**MEMO**

AMEC File No. VM00560B

Date 28 July 2014

Subject Mount Polley Mine TSF Expansion

FIGURE 1
MAP OF THE LOCATION OF THE MOUNT POLLEY MINE

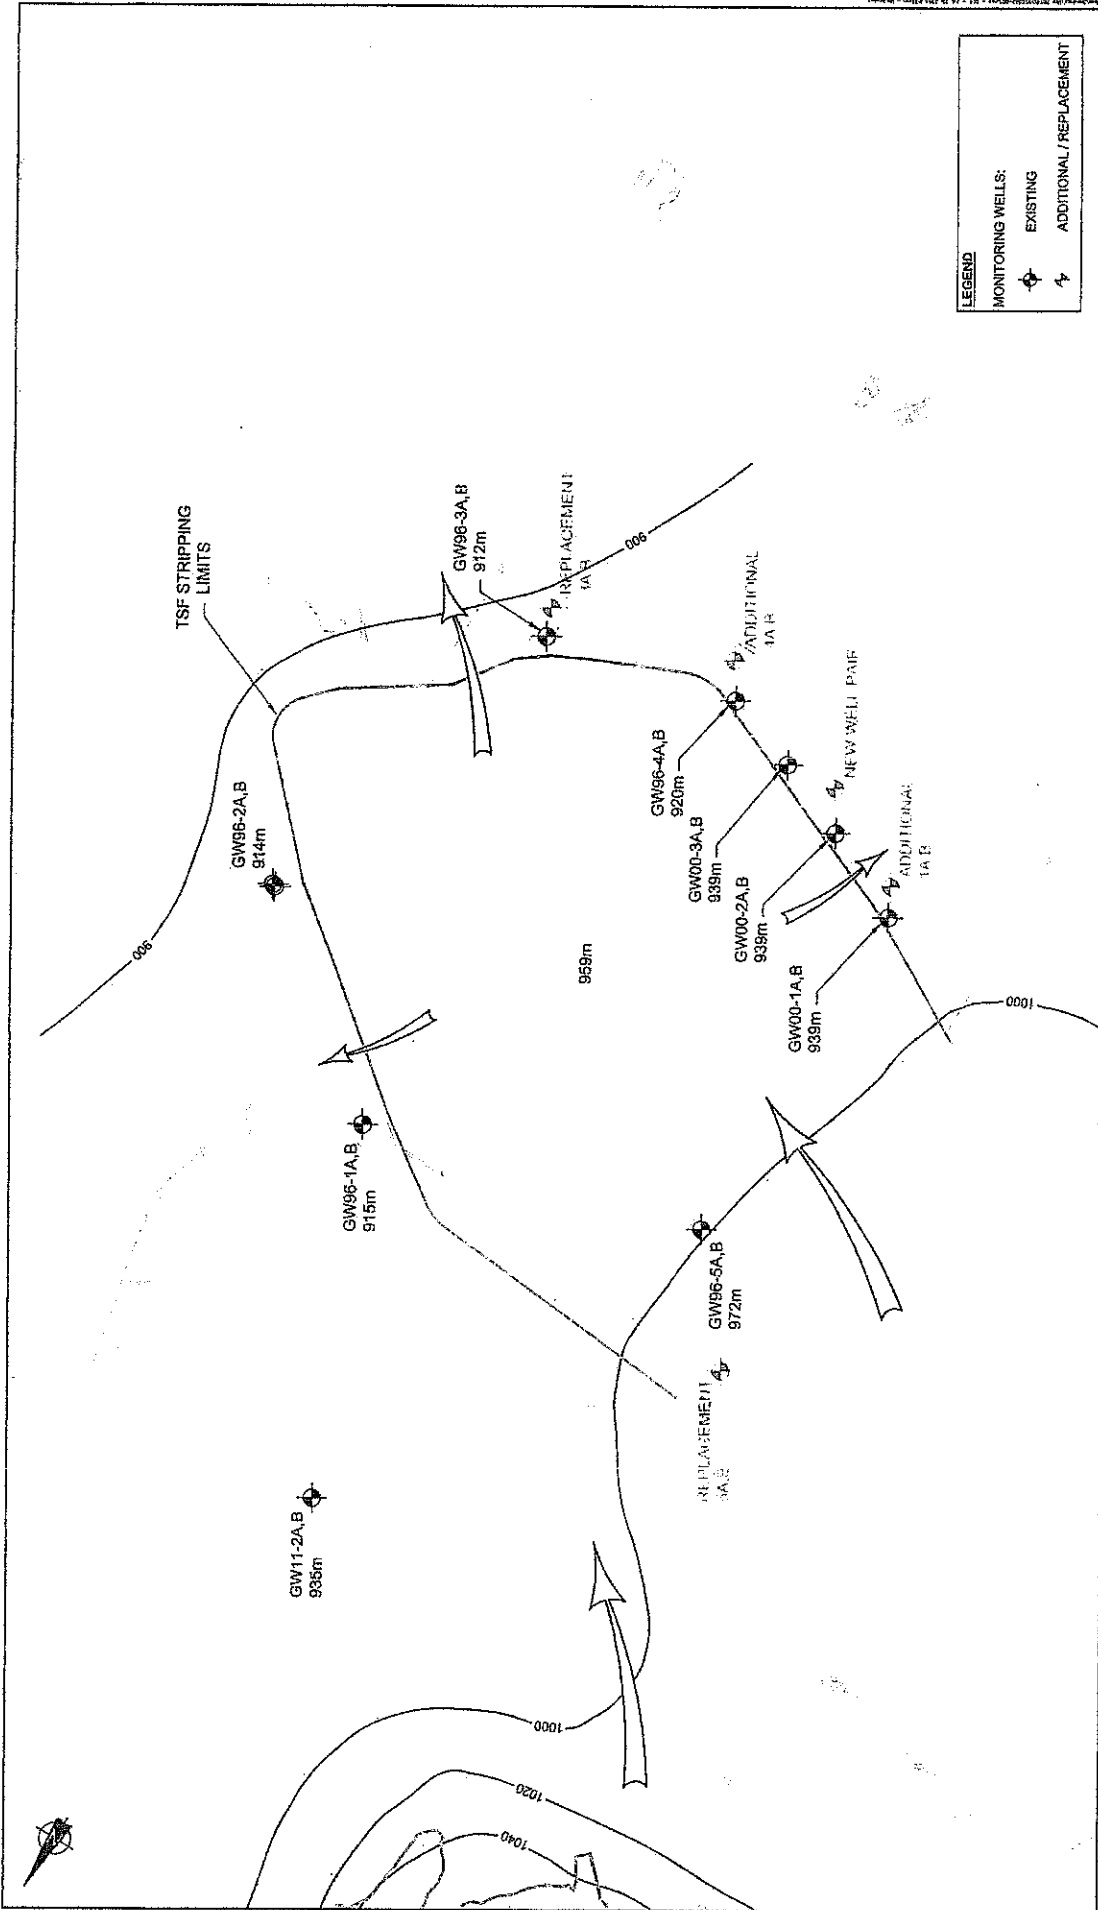
- Wells GW00-1A/B, GW00-2A/B, GW00-3A/B, and GW96-4A/B are all very close to the proposed stripping limits and well GW96-3A/B is near an existing pond that will likely be decommissioned as part of the expansion.
- Monitoring well GW00-1A/B is the only well with a strong upward trend in some parameters suggesting some influence from the TSF.
- Monitoring wells GW96-2B and GW96-4B each show some indication of upward trend in some parameters.

- GW96-3A/B is close to the seepage recovery pond which will likely need to be moved putting this monitoring well pair within the construction area. This pair should be relocated downgradient as shown on Figure 1.

- GW00-1B and GW96-4B each show some indication of impact from the TSF. Each of these wells should be retained and additional wells constructed downgradient to measure the extent of the impact, Figure 1. Water quality should be monitored in both the existing and new wells for a period of one year. The existing wells can be abandoned after that.

- GW00-2A/B and GW00-3A/B do not indicate any impact from the TSF. These two well pairs can be replaced by a single well pair as shown on Figure 1.
- GW96-5A/B has been decommissioned. This well served as an upgradient monitoring well. Upgradient monitoring wells are important in the interpretation of water quality trends in monitoring wells surrounding the TSF. Consideration should be given in replacing this well pair at a location upgradient of the TSF (Figure 1).

All of the existing monitoring wells are close to the limits of the tailings facility expansion. Only one should be retained with some focussed effort, GW00-1A/B due to water quality trends. One well will require moving due to proximity to expected construction efforts, GW95-3A/b. All other wells can theoretically be retained. There is a danger in retaining any of these wells during construction that they will be damaged. The construction contractor may have significant complaints in retaining these monitoring wells and it may increase the cost of construction. There is no technical reason to retain these remaining wells and all can be replaced if required for logistical reasons in tailings expansion construction, Figure 1.
